## **ADDENDUM NO. 1**

### **FOR PROJECT NO. S.A.P. 042-599-145**

Project Title or Road Number: Rock Lake Bridge L5810

ESTIMATED QUANTITIES  
STATE AID PROJECT NO. 042-599-145 SHEET 02 OF 08 SHEETS

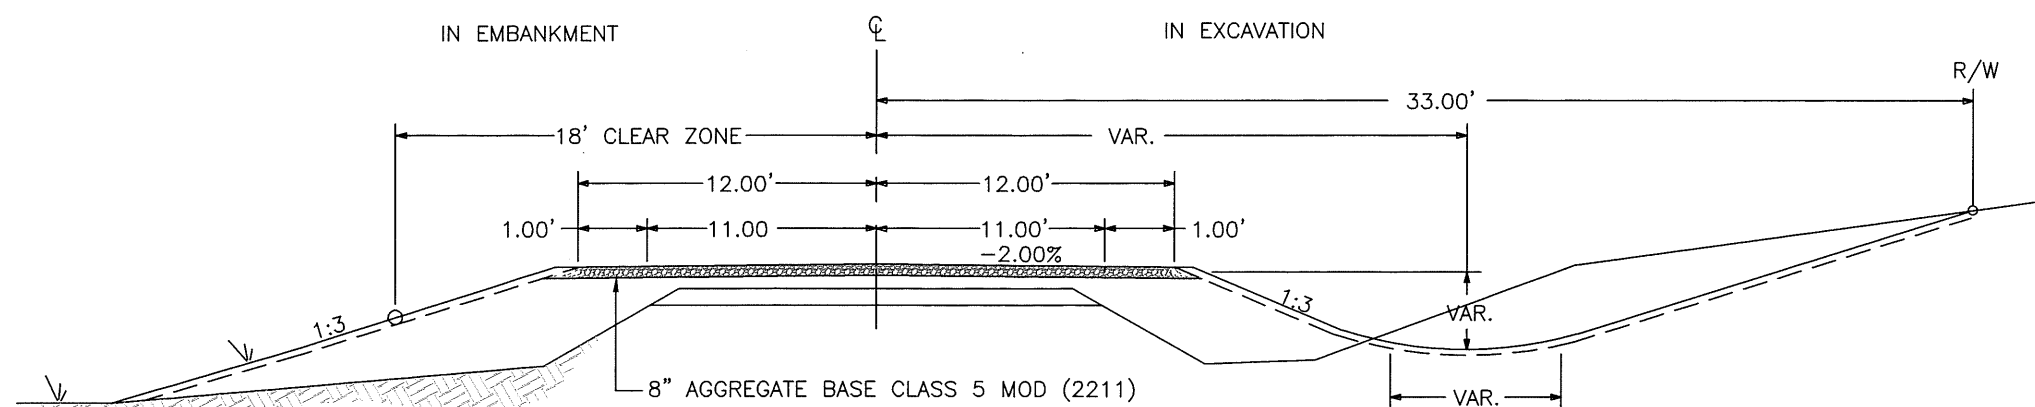
**2412.511 – 12x7 PRECAST CONCRETE BOX CULVERT**  
**2412.511 – 12x8 PRECAST CONCRETE BOX CULVERT**  
**2412.512 – 12x7 PRECAST CONC. BOX CULV END SECT**  
**2412.512 – 12x8 PRECAST CONC. BOX CULV END SECT**

**TO**

**2412.511 – 16x7 PRECAST CONCRETE BOX CULVERT**  
**2412.511 – 16x8 PRECAST CONCRETE BOX CULVERT**  
**2412.512 – 16x7 PRECAST CONC. BOX CULV END SECT**  
**2412.512 – 16x8 PRECAST CONC. BOX CULV END SECT**
